Re: Planning application for a 110 kilovolt electricity substation, approximately 7.5 kilometres of underground electricity line and all associated works at Moyvannan, Feamore, Lisbaun, Carrownolan, Carrowncloghan, Carrowkeeney, Ardmullan, Curraghboy, Gortnasythe, Derryglad, Eskerbaun, and Brideswell, County Roscommon, as described at <https://moyvannansubstation.ie> .
ABP Case Reference: 321238

Please see below my objections and questions on this development plan.

5. Map of proposed substation and wind farm

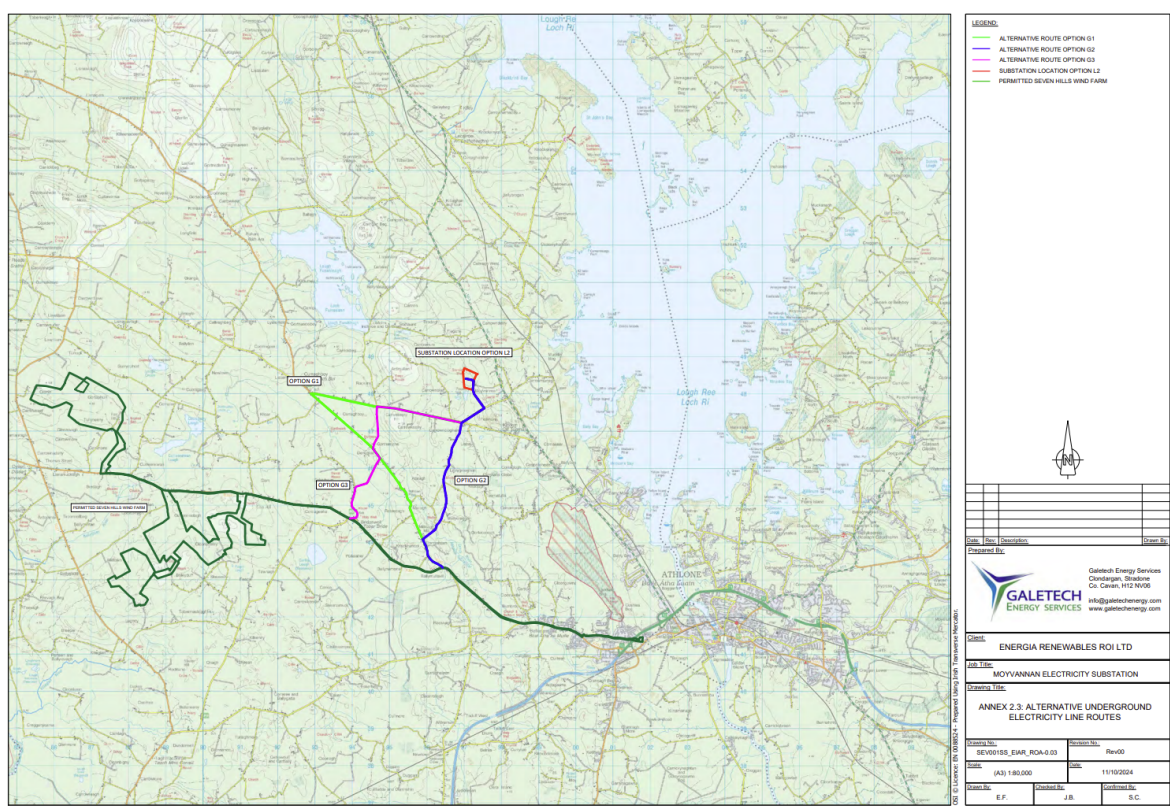
For example, the above image from <https://moyvannansubstation.ie/media/bbhaq0j/annex-16-community-consultation-report.pdf> does not map out any of the water features, such as Cross River, despite Cross river been mentioned elsewhere as one of the challenges of the development.

<https://moyvannansubstation.ie/media/ij5h4iaj/annex-51-figures.pdf>

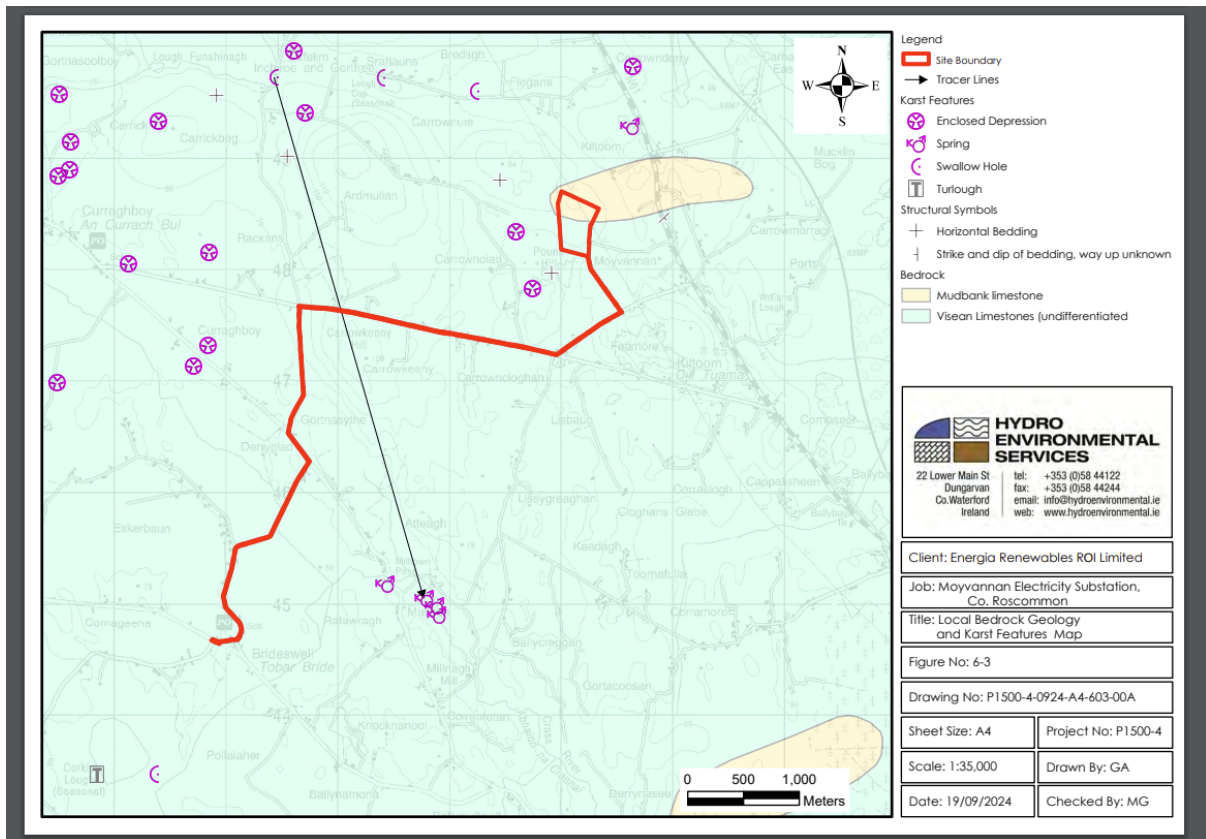
The developer maps, have no treatment or display for water features, and is very hard to follow the course of this proposed route. Also, is this for just one of the proposed underground cabling lines? We object also, as no data is showing the second proposed route, with similar data and it is a struggle to understand the implications of the route.

<https://moyvannansubstation.ie/media/k5rc5uxy/annex-63-figures.pdf>

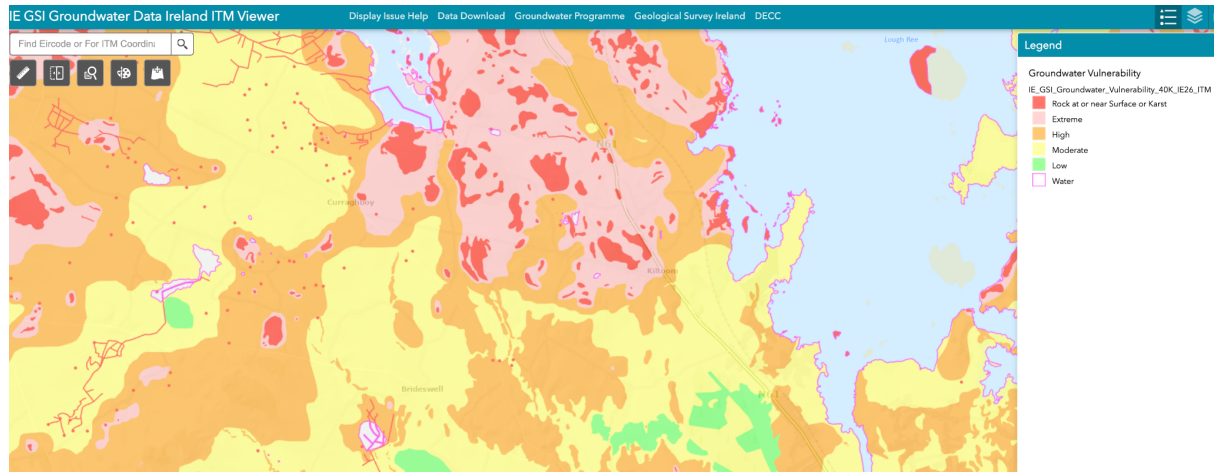
This seems to be the only map showing the route and its water features. It is very low-resolution, and I find it hard to understand since it is so zoomed out. For example, where are the underground water supplies marked out on the map and is there a version available that I can zoom in on to see details more clearly? It would be a challenge for any member of the public or I, to have a clear understanding of the impact of the route on the water supply based on the above map.

How can I present well-informed submissions or objections to this development when the exact area for the underground cables from Moyvannan remains undefined?

Figure Annex-63 : <https://moyvannansubstation.ie/media/k5rc5uxy/annex-63-figures.pdf>

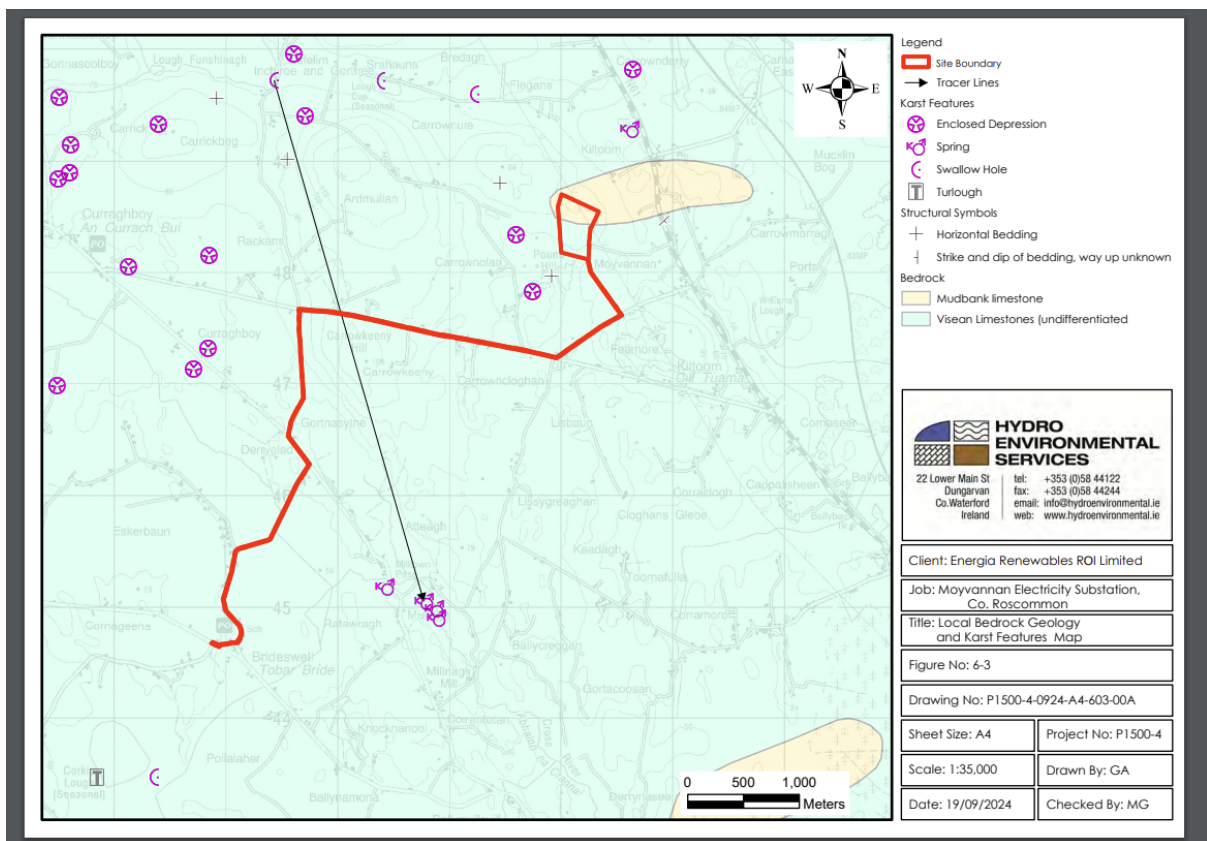
Both maps highlight critical groundwater karst features that are conspicuously absent in Figure Annex-63 (available at: [Annex-63](#)). This oversight demonstrates that the proposed development has failed to utilise the latest data from the GSI and other authoritative government sources to accurately map the water features of the karst landscape. As a result, I strongly object to the approval of this project.
